**ZONING AMENDMENT,
PLANNED UNIT DEVELOPMENT &
SUBDIVISION STAFF REPORT**

Date: October 2, 2003

Brookview at Brookside Subdivision

DRAINAGE SITE PLAN

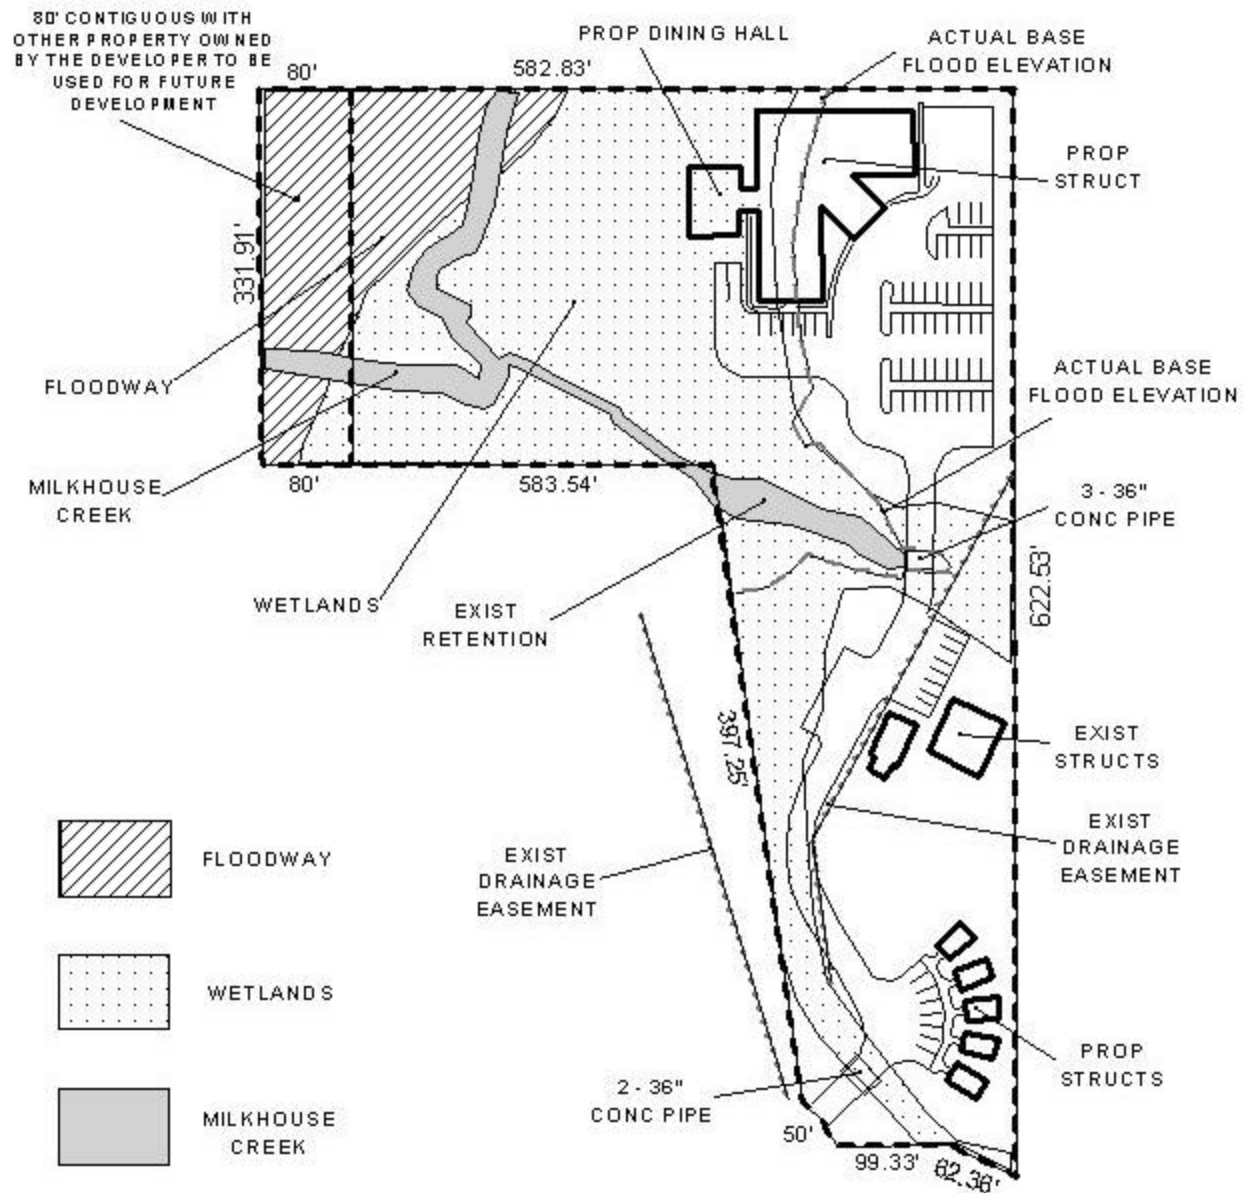
Information submitted by applicant indicates actual floodway and floodplain are shifted to the east where the new structures and parking are proposed. This further complicates development of this property. The proposed building and parking encroaches into the wetlands adjacent to Milkhouse Creek. As with all applications of this type complete compliance City of Mobile stormwater regulations (inc. FEMA) will be required.

There are numerous problems associated with the proposed site plan. The plan illustrates that both the edge of the wetlands and the actual base flood elevation line are located well within the footprint of the proposed assisted living facility. Additionally, the entire dining hall, as well as some parking, are also within the wetlands. Planned Unit Development approval is site plan specific, and while minor modifications to the building footprint may be made, the Commission has consistently prohibited building construction in delineated wetlands, thus necessitating a complete redesign of the site plan.

DETAIL SITE PLAN

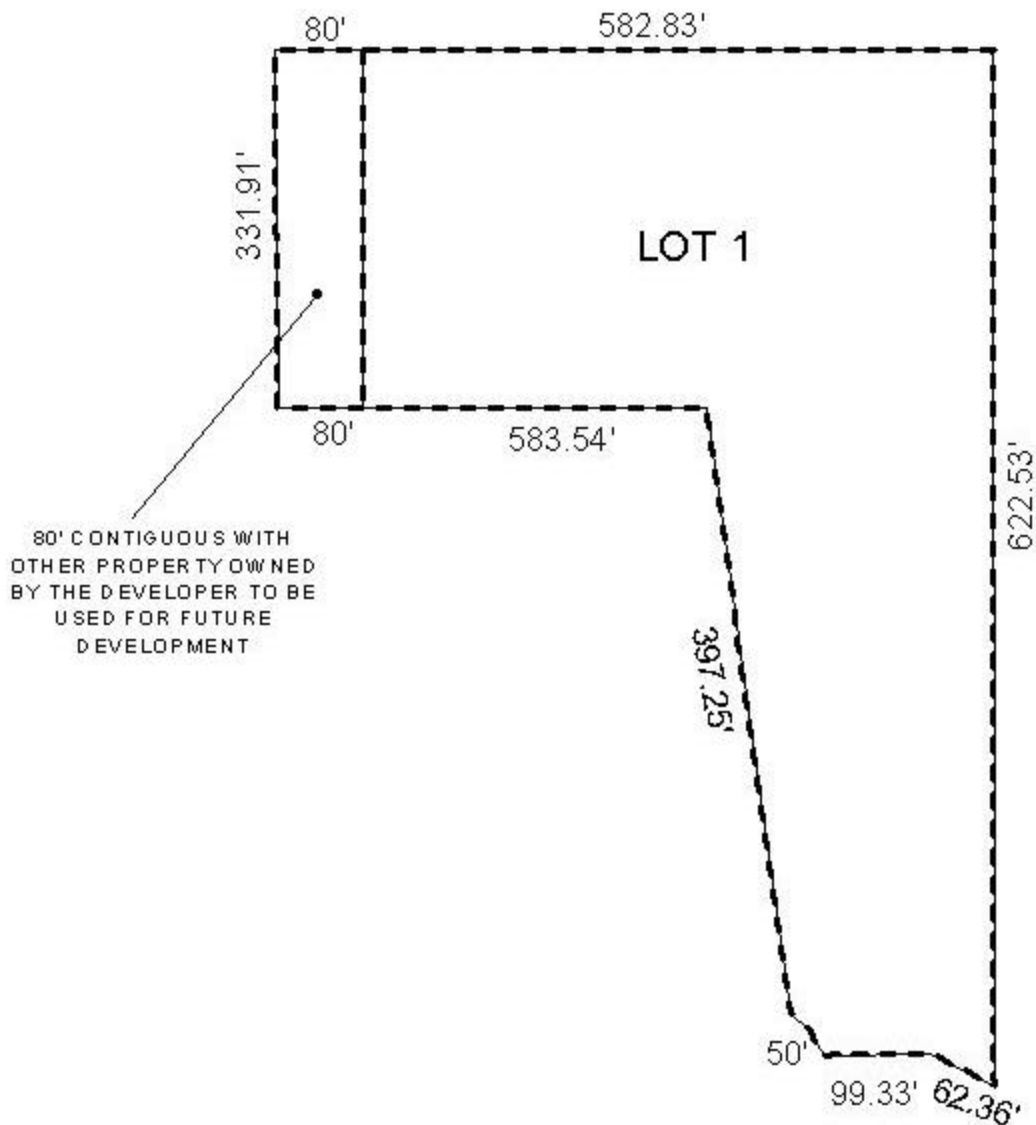
The applicant has submitted a revised plan that illustrates contours, watercourses, wetlands, base flood elevation lines, and easements. Also shown on the plan is a note that the western 80-foot (which appears to be the balance of the property from which the lot is being taken) is "contiguous with other property owned by the developer to be used in future development." The "other property owned by the developer" appears to be Lot 9 of Moss Creek, as referenced in the Engineering Comments above.

In regard to the proposed subdivision, there is a note on the plat stating that there is "80' contiguous with other property owned by the developer to be used in future development." Approval of the subdivision as proposed would leave the 80' parcel unaccounted for and essentially validate a land-locked metes and bounds parcel.
